## ADDENDUM NO. 1, September 30, 2020 *(Revised October 1, 2020)*

RE: POK-DIP 151C  
Project No. 2190380.01

FROM: **Mackenzie**  
The Hudson Building  
101 E 6<sup>th</sup> Street, #200  
Vancouver, WA 98660  
(360) 695-7879

G1.10

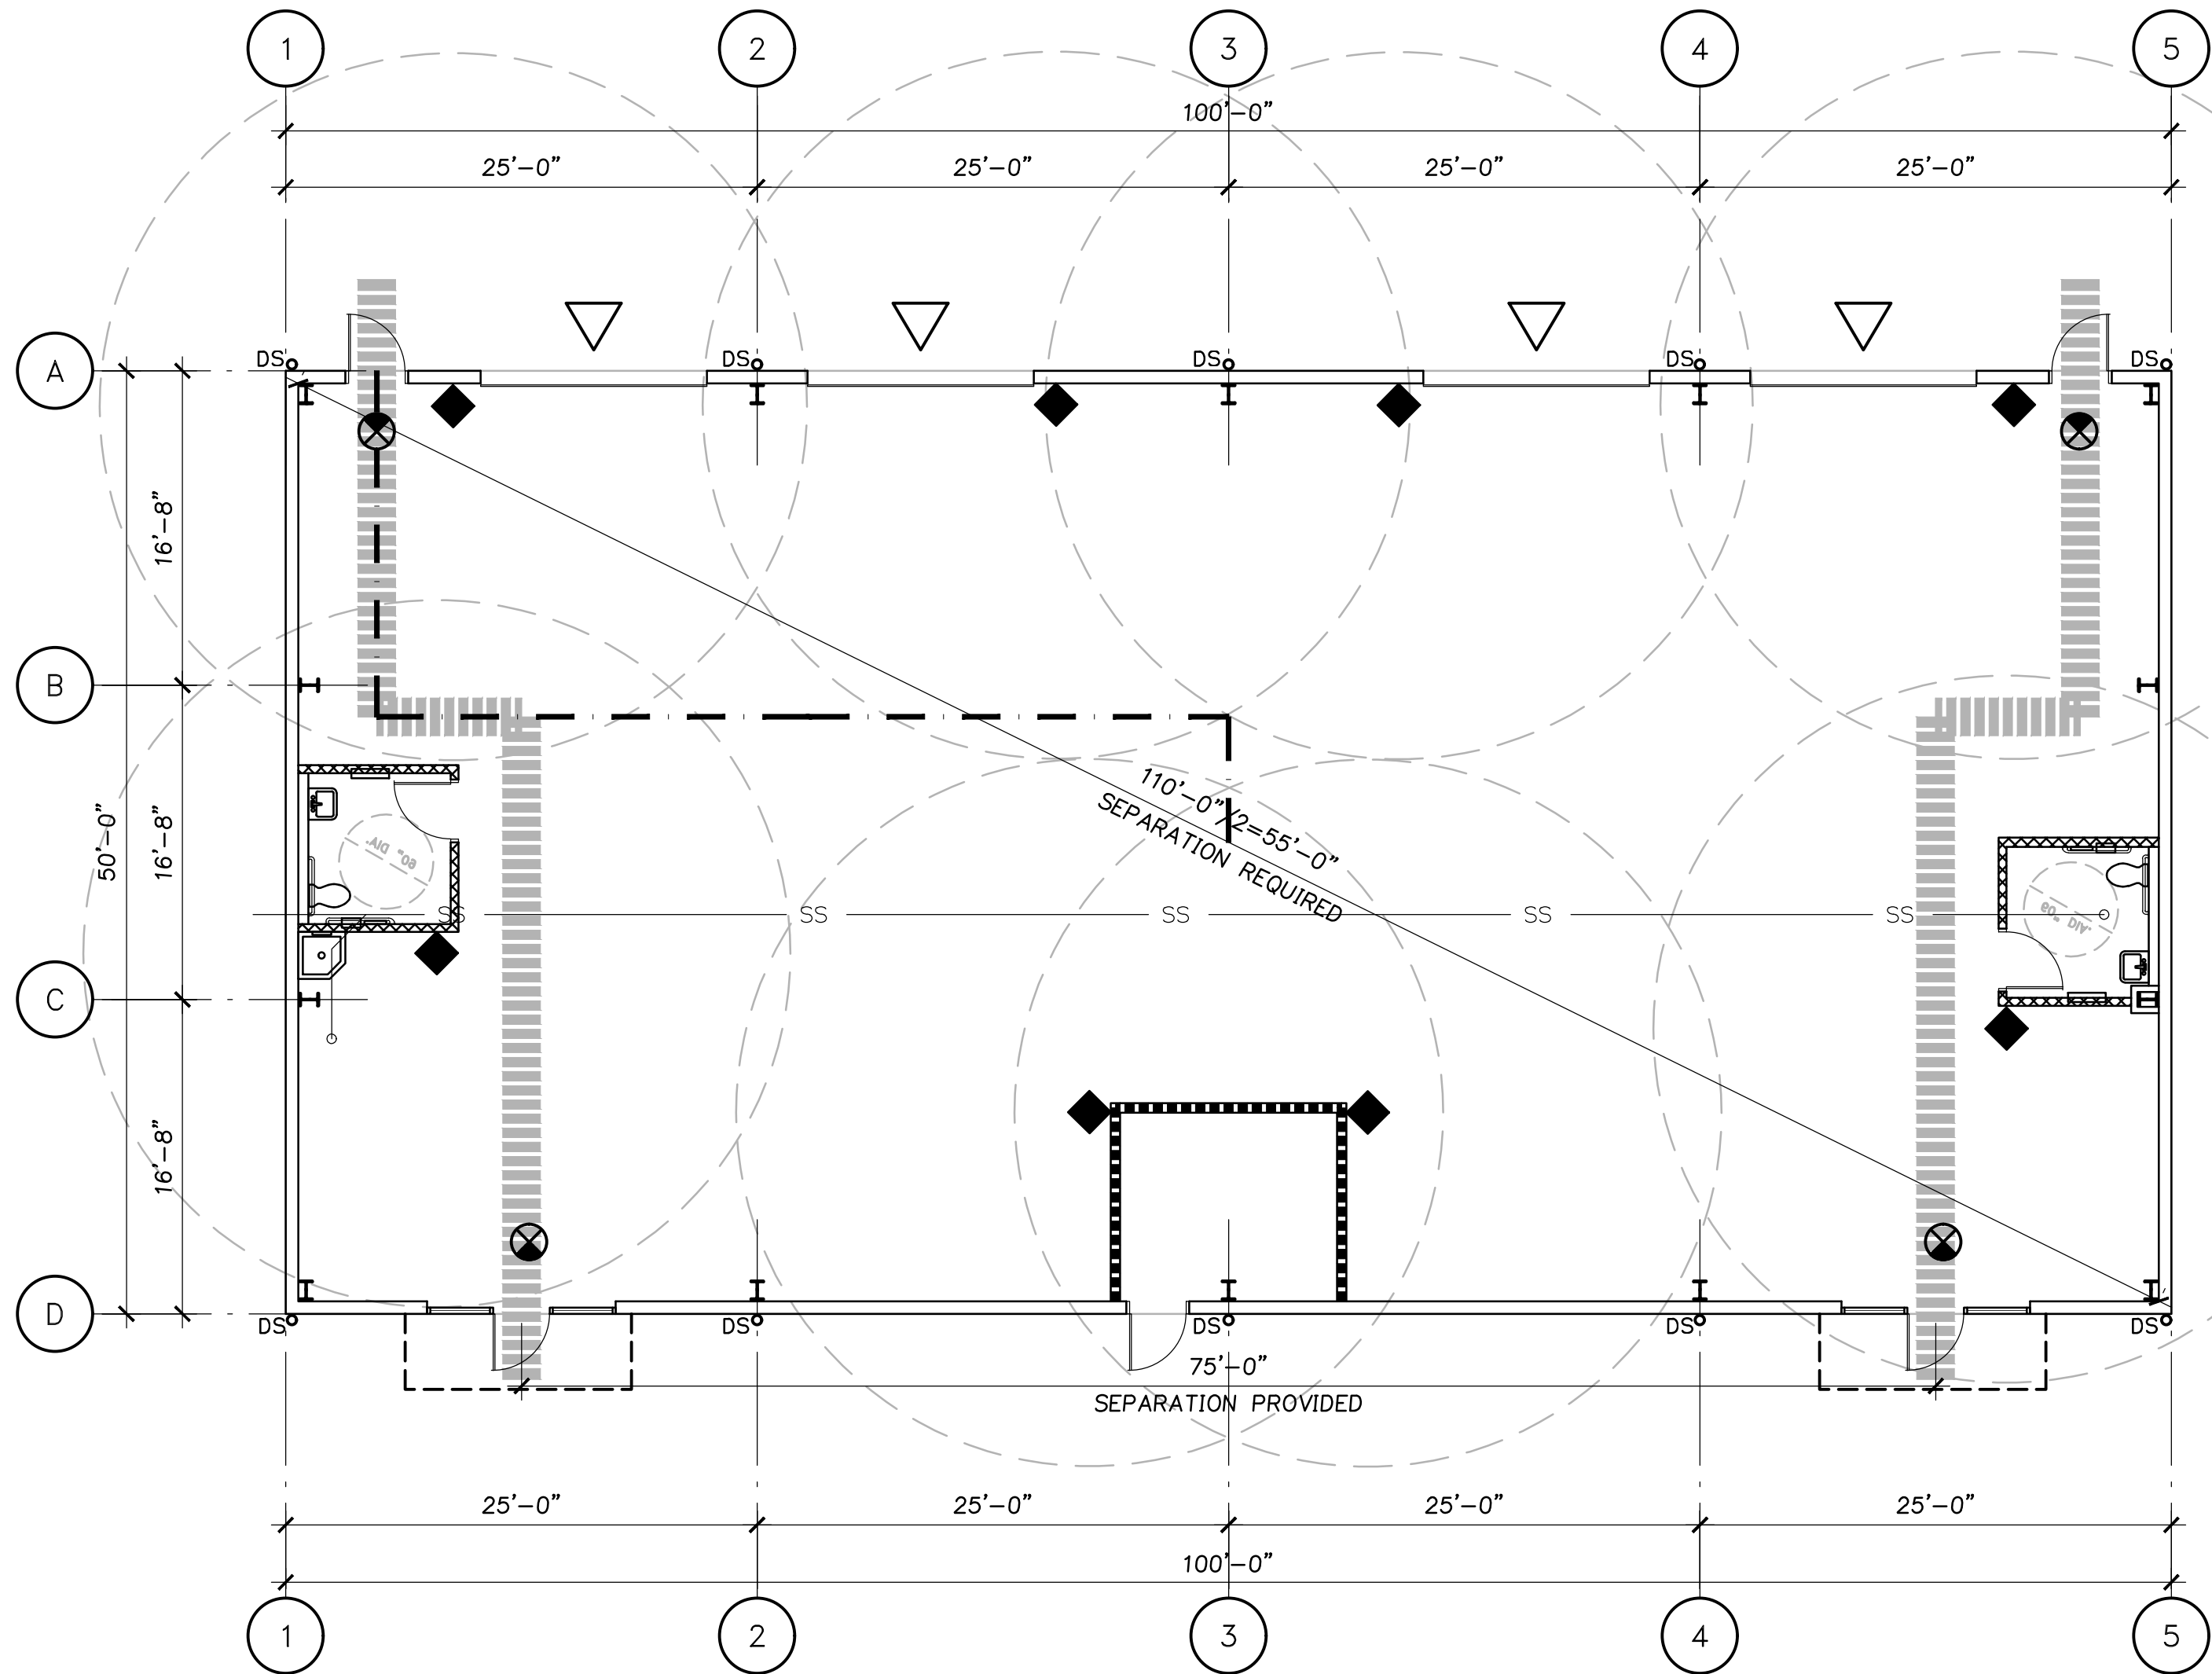
| ARCHITECTURAL DOCUMENT CHANGE LOG                                                          |                |               |               |                               |              | Mackenzie<br>1515 SE Water Ave, Ste 100, Portland OR 97214 (503) 224-9560                                                                                                                                                                                                                                                                               |
|--------------------------------------------------------------------------------------------|----------------|---------------|---------------|-------------------------------|--------------|---------------------------------------------------------------------------------------------------------------------------------------------------------------------------------------------------------------------------------------------------------------------------------------------------------------------------------------------------------|
| G1.10                                                                                      | ADDENDUM #1    | A             | 9/30/2020     | 3                             | 1,2,3        | REVISED CONSTRUCTION TYPE TO IIB, REMOVED FIRE PROTECTION CALL OUT, REVISED S-1 CALLOUT, AND ADDED F-1 INDUSTRIAL CALLOUT                                                                                                                                                                                                                               |

A0.01  
JOB NO. 2190380.01

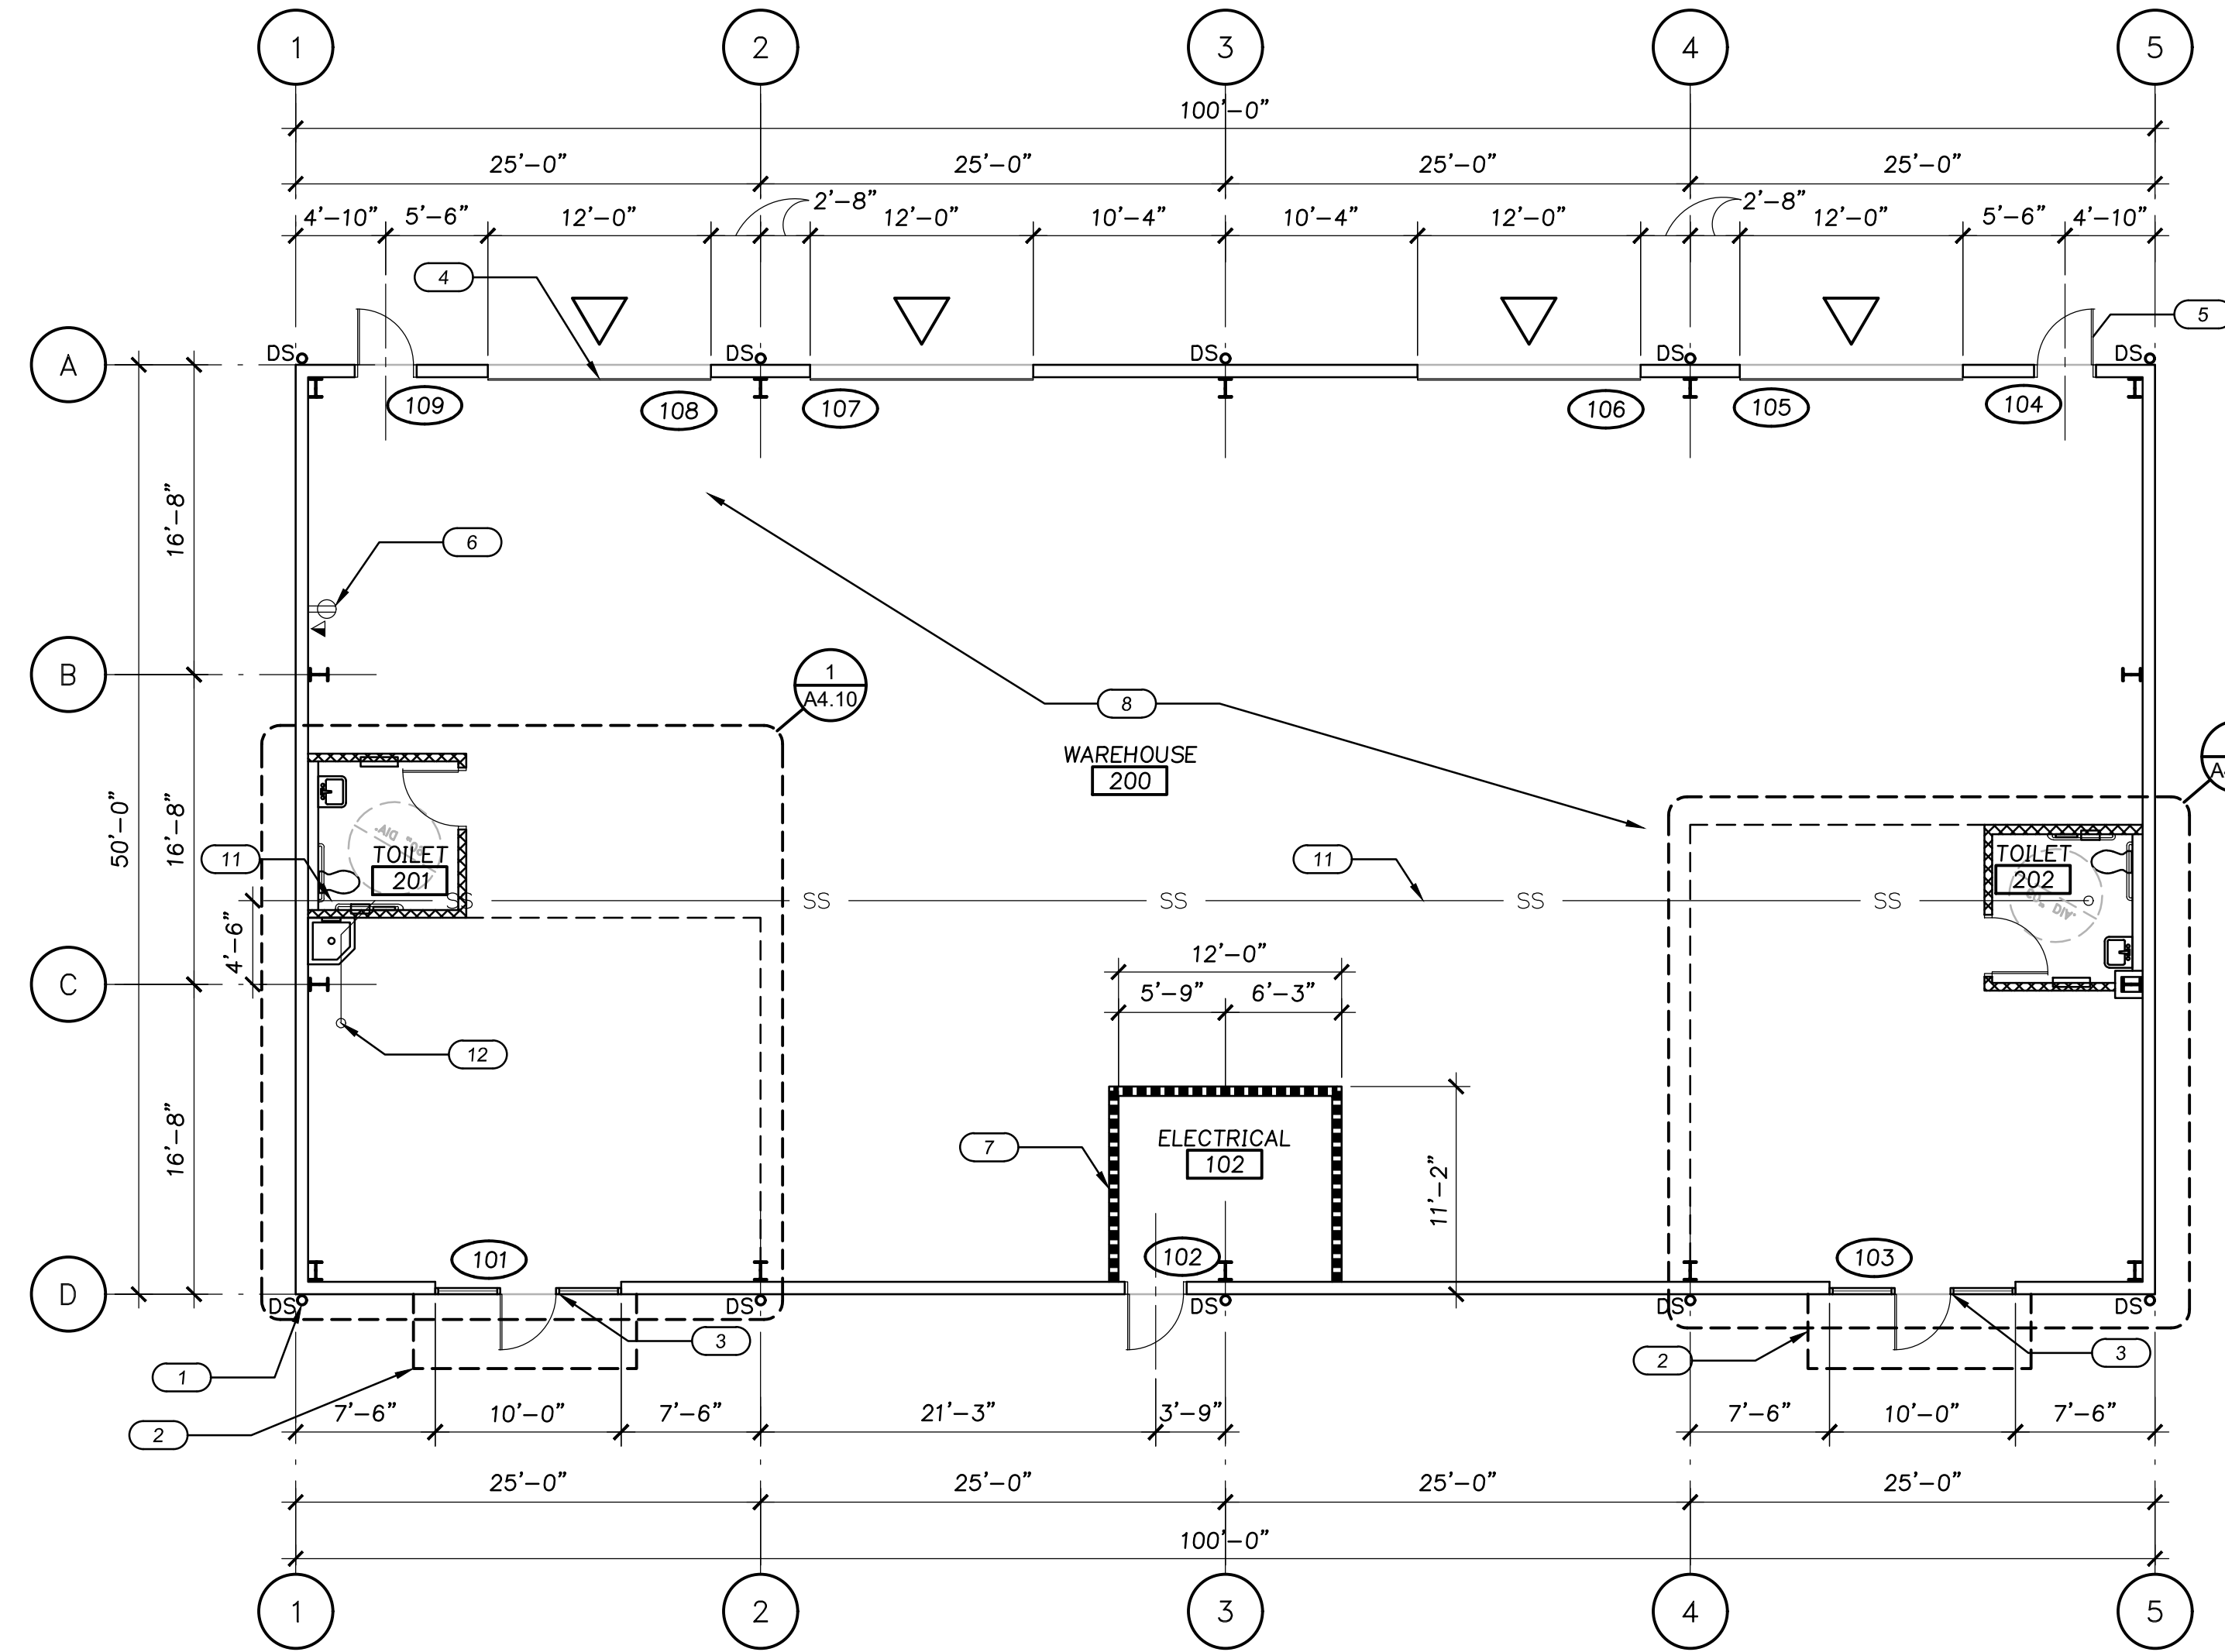
- A. The note is directing you to G1.10 Code Summary. There are however no fire rated walls and this note has been removed from Sheet A0.01.
37. Drawing A0.01 Architectural General Notes, Note Z is this in reference to the two canopies shown on A1.10 and A2.10 (south elevation)?

- A. Office areas will be provided at future tenant improvement, furring at toilet room only, see detail 3/A5.20. Note Y from A0.01 has been removed.
39. Drawing A2.10, please verify the bottom elevation of these two canopies is 110 ft AFF.
